UNITED STATES PATENT AND TRADEMARK OFFICE

APPLICATION NO.	FILING DATE	FIRST NAMED INVENTOR	ATTORNEY DOCKET NO.	CONFIRMATION NO.
09/925,562	08/09/2001	G. David Jang	S63.2-9950	6986

Office Action Summary

FIG.2A

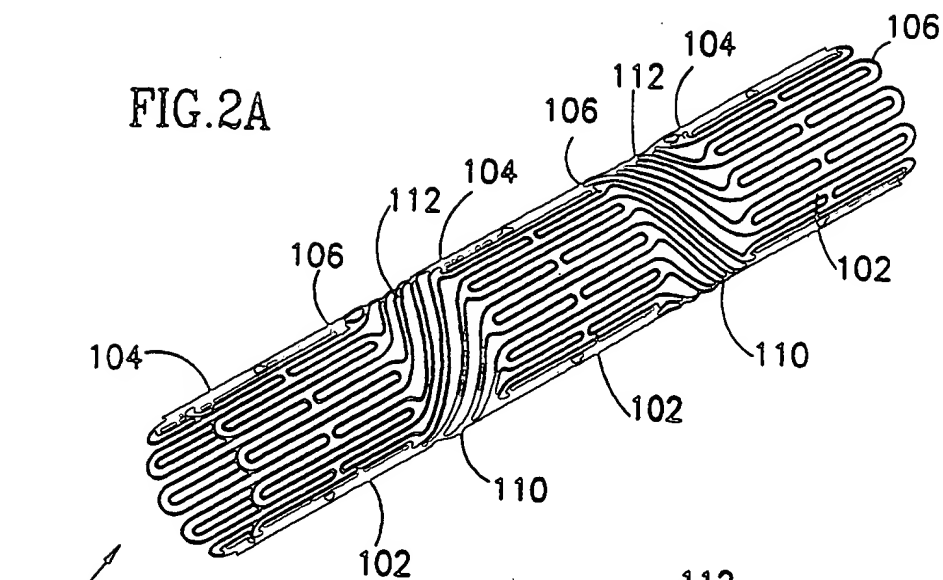
Claims 34, 36, 39, 40, and 42-50 are rejected under 35 U.S.C. 102(e) as being anticipated by Pinchasik et al (US 5,449,373). Pinchasik anticipates the claim language where the first, second and third expansion columns as claimed are the first, second, and third segments (102) of Pinchasik; see Figures 2A to 2C. Applicant is directed to that attached marked-up Figure 2C which shows the expansion struts of segments (102) in red. The other struts (in green) are not precluded by the present claim language.

Alternatively, one could view Brown as not anticipating the claim language because one could say that elements (19a, 19b) are not part of the connecting elements. However, Pinchasik teaches that it was known to make curved interconnectors between adjacent segments; see Figures 2A to 2C and 3A to 3C. Therefore, the Examiner posits that it would have been obvious to make the interconnectors of Brown curved for the same reasons that Pinchasik does the same and in order to better support the area between the segments.

FIG.2B

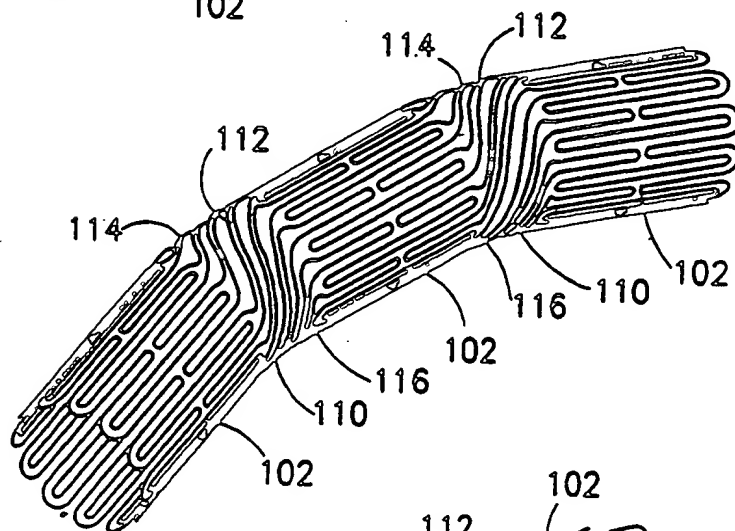
The arguments set forth in the February 10, 2003 amendment are considered moot in view of the manner in which the Pinchasik reference is now being applied. In particular, the first, second, and third expansion struts as claimed read on the red highlighted segments set forth in the attached Figure 2C.
